AMENDMENT NO. 1 TO:

PROJECT: Noble Terrace over Barton Brook - Culvert Replacement

FEMA PROJECT NO.: 766429

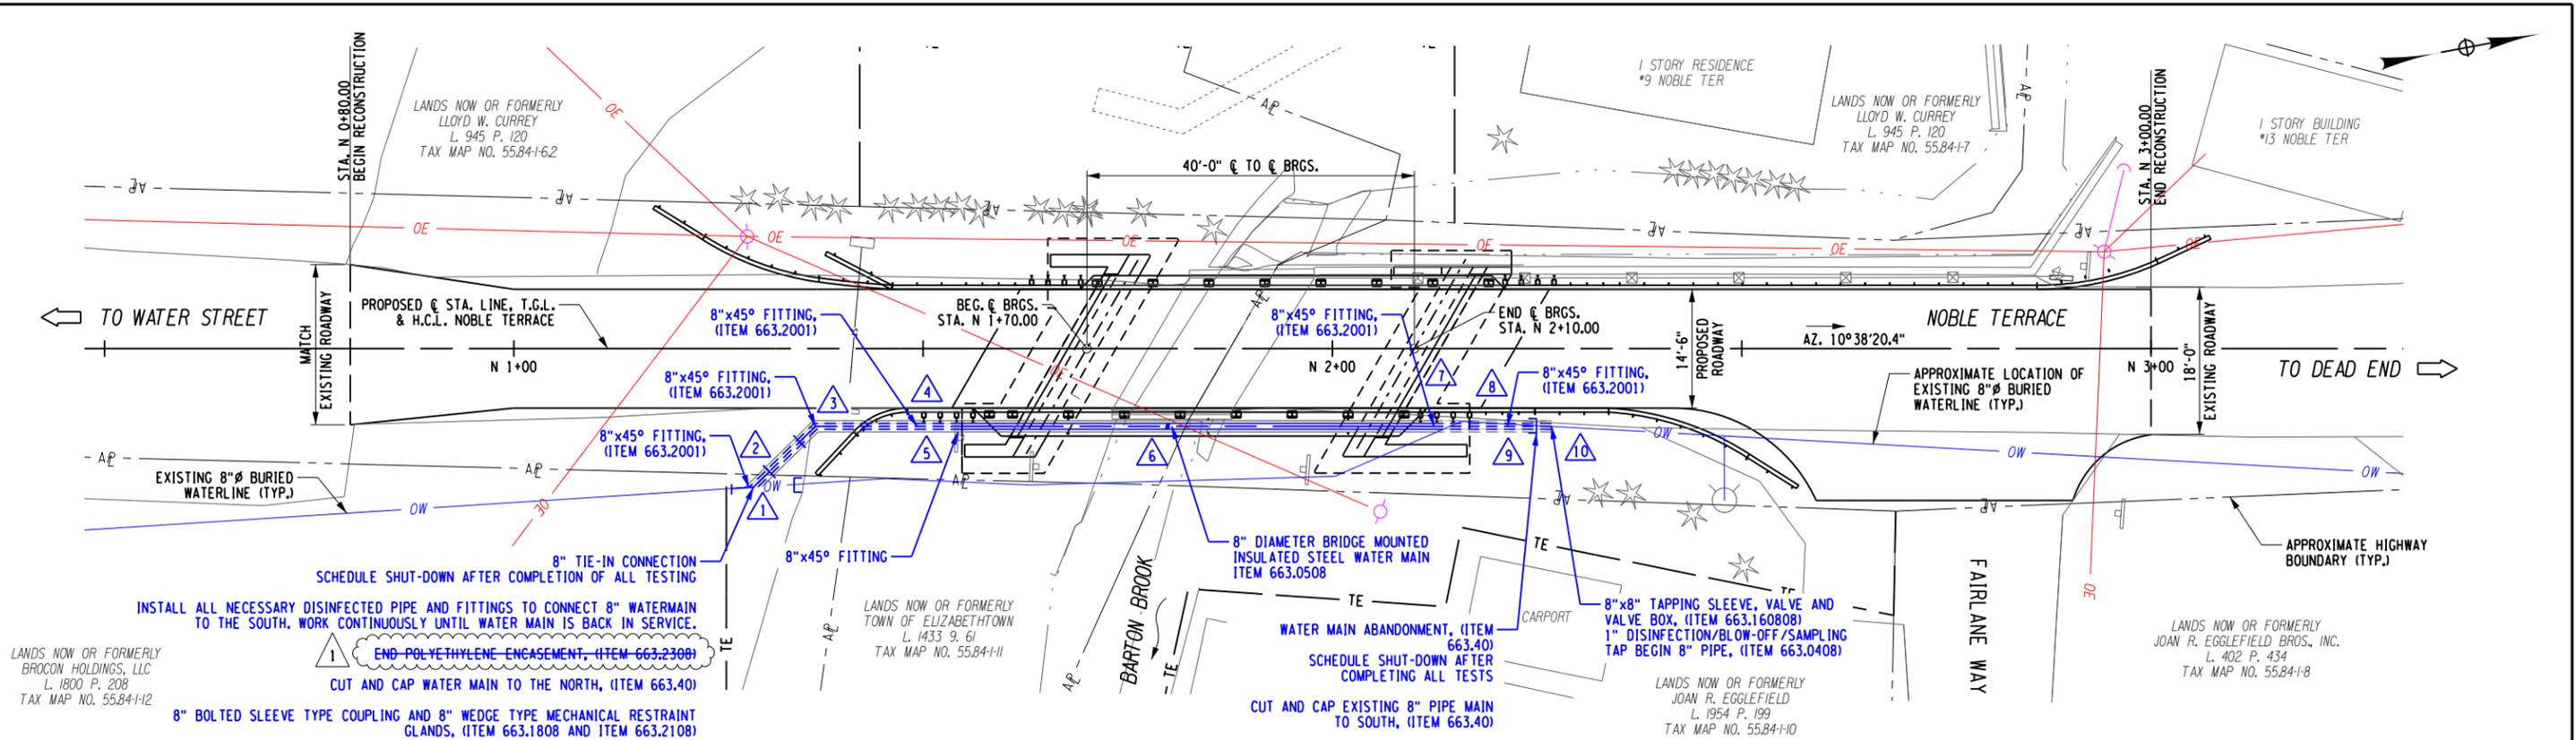
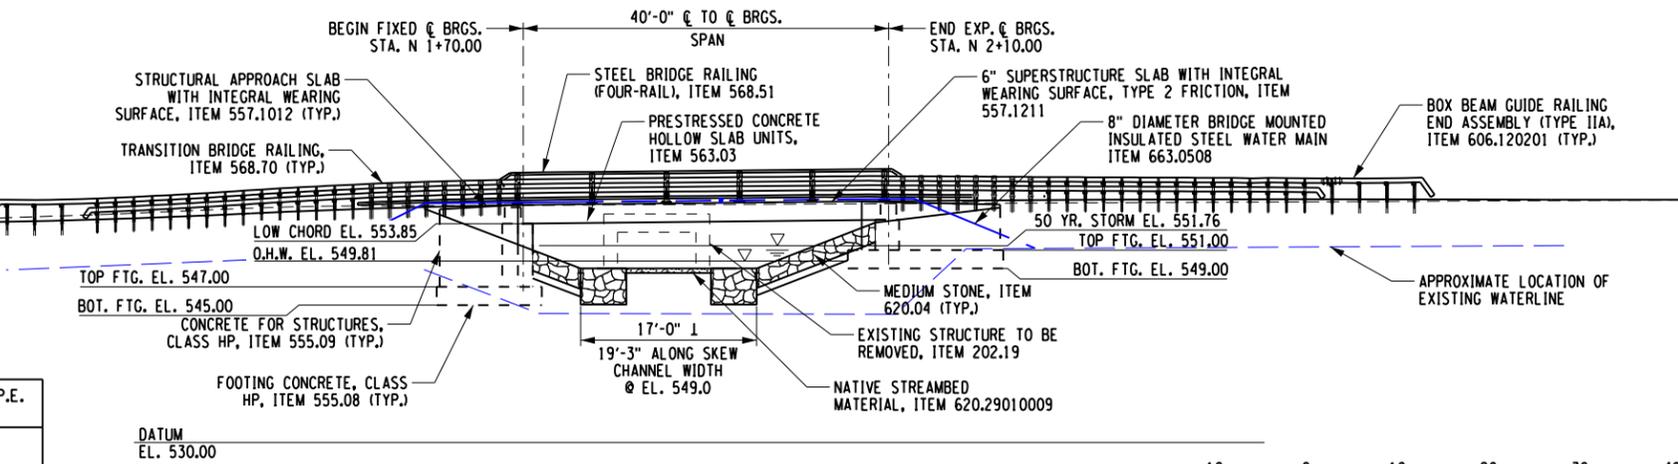
- ST-1 – Treatment of utility pole at northwest quadrant has been updated to be protected.
- ST-19 – Item 663.2300, End Polyethylene Encasement has been removed.
- ST-19 – PVC Water Main notes have been removed.
- ST-20 - Item 663.2300, End Polyethylene Encasement has been removed from the Waterworks Table.
